1. 11 Mall Road - Game On & Loretta's Last Call

Re: Exterior design
11 Mall Road-Loretta's Last Call & Game On!
Langan Project No.: 151064501

Below please find our responses comments discussed in our December 9, 2025 meeting and at the PB meeting. Below please find each comment followed by our response in **bold.**

LYONS GROUP RESTAURANT
AT THE MALL AT ROCKINGHAM PARK
PLANNING BOARD SUBMISSION

EXTERIOR ELEVATIONS

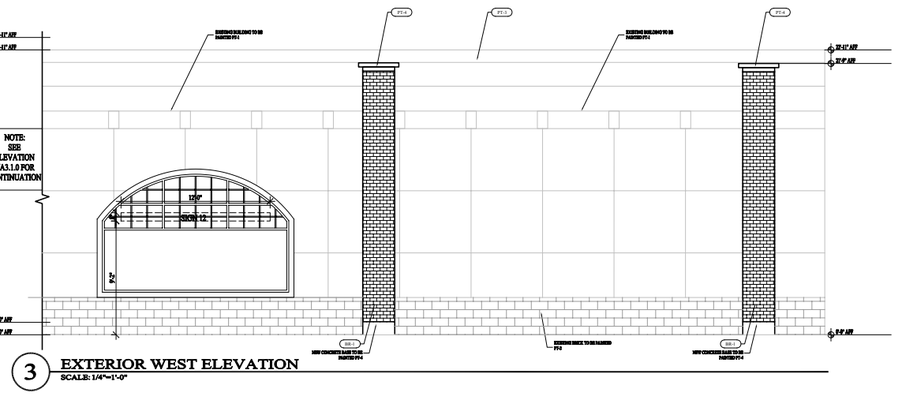
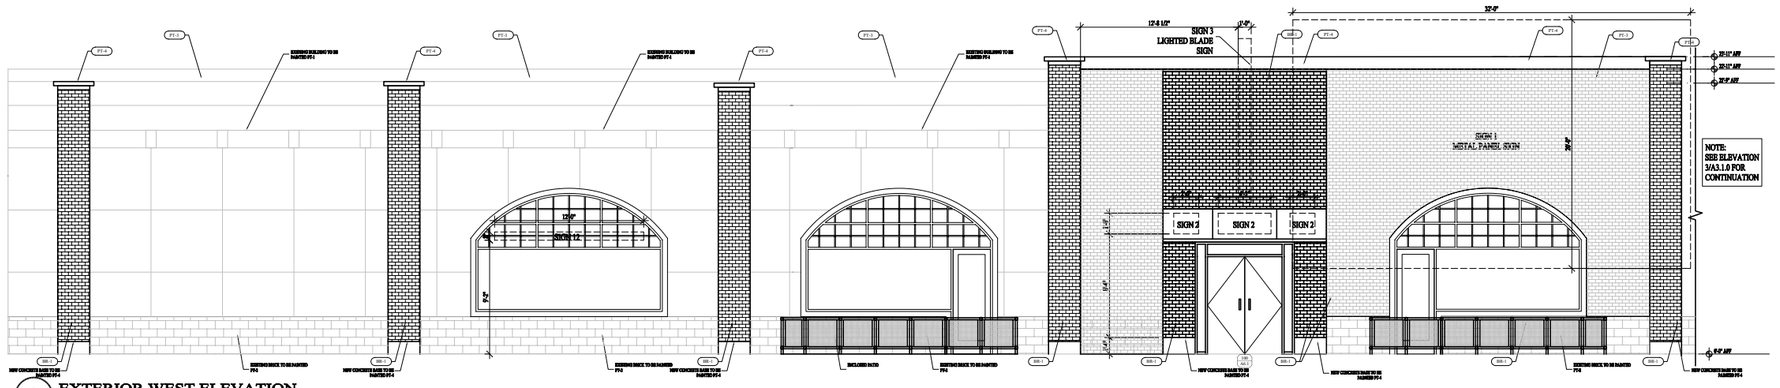
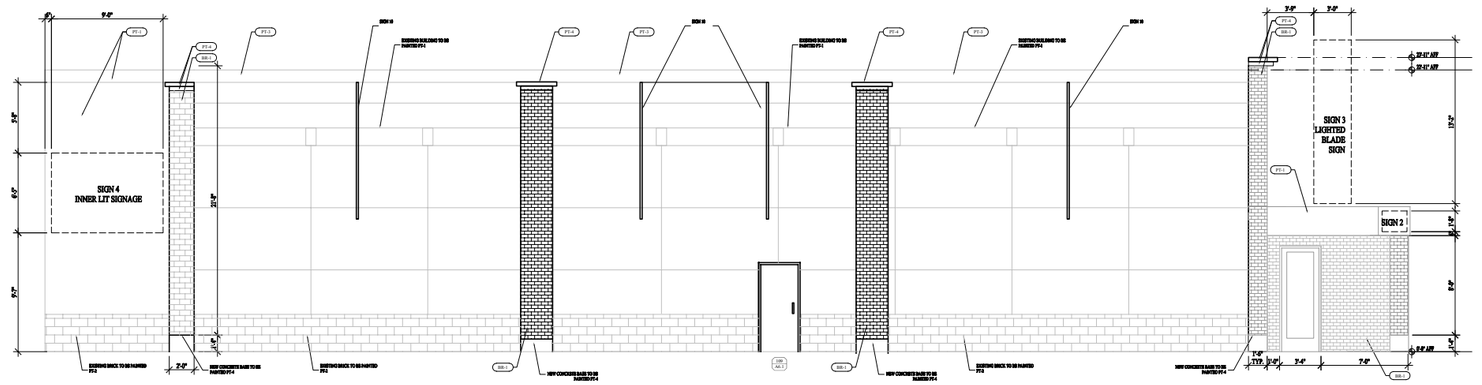
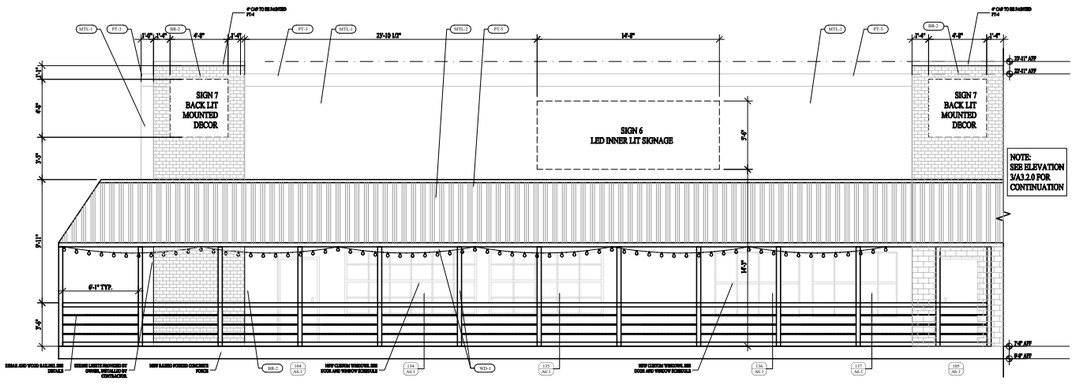
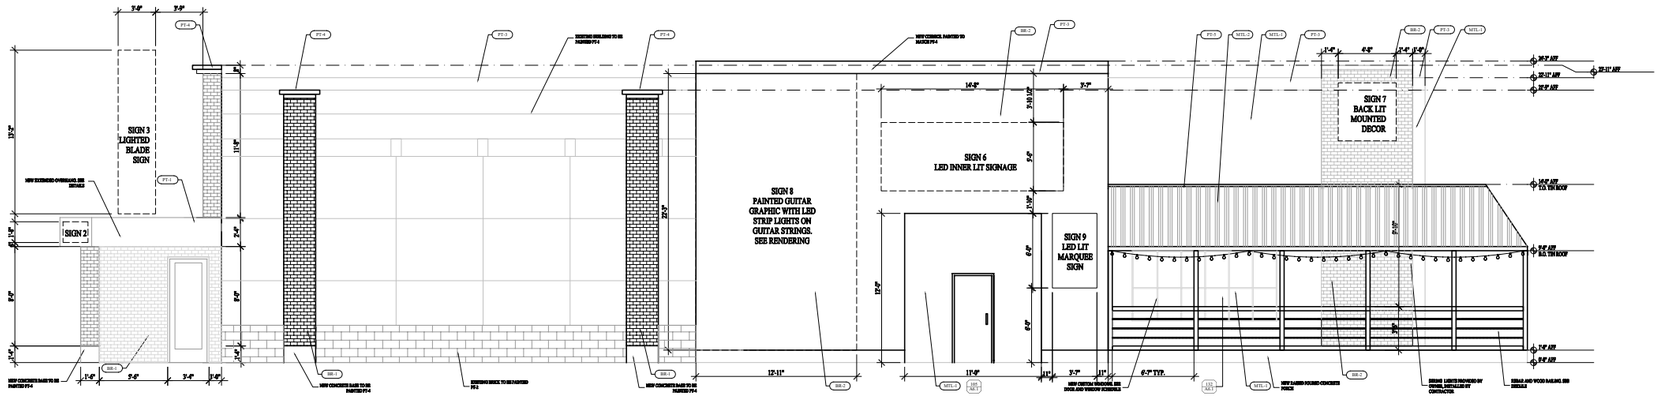
- See Design Guidelines for Façade Design – pages 30-33
    - "For retail structures, any facade that faces a public or private street should have display windows, entry areas, or other transparent features along 40% or more of its horizontal length… Facades should not extend for more than 50 horizontal feet in length without incorporating architectural features, such as pilasters, windows, cornices, porches, corners, or offsets."

- Please see staff comments: "elevation drawings provided: proposing to retain significant portion of existing façade and paint to match Fenway Park motif – existing brick to be painted red, existing concrete wall to be painted green, cornice to be painted black; adding new Game On entryway on west side of building with brick columns, - have eliminated awning, patio enclosed by black steel fence, new windows and new projection on façade for signage; Loretta's Last Call to have western motif – rusted tin roof panel, catenary lights, new windows, brick façade entrance, new patio enclosed with rebar and wood railing

COMMENT RESPONSE: **This concern was addressed by adding the large window on either side of the entrance as well as two additional large windows beyond those two windows that are decorative.**

COMMENT RESPONSE: This concern was addressed by adding the large window on either side of the entrance as well as two additional large windows beyond those two windows that are decorative. In addition, we have added banners on the North side of the building as well as an additional pilaster on the east face behind the equipment enclosure.
